Strut mount to fit BMW E30, E36, E46, Z1, Z3, Z4

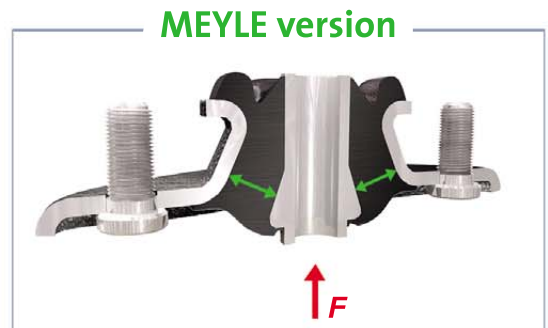
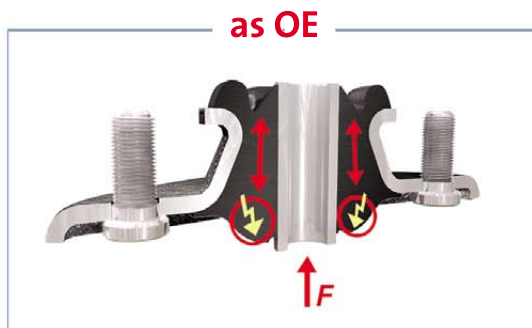
<div style="display: flex; justify-content: space-between; align-items: center;"> as OE Problem </div>	<div style="display: flex; justify-content: space-between; align-items: center;"> Solution </div>
<p>Failure of the rubber to metal compound between the inner bushing and the housing</p>	<p>Reinforcement of the rubber to metal compound by surface extension</p>
Effect	Advantage
<p>Loud noise and reduced driving and braking safety</p>	<p>Significant longer lifetime, higher safety</p>
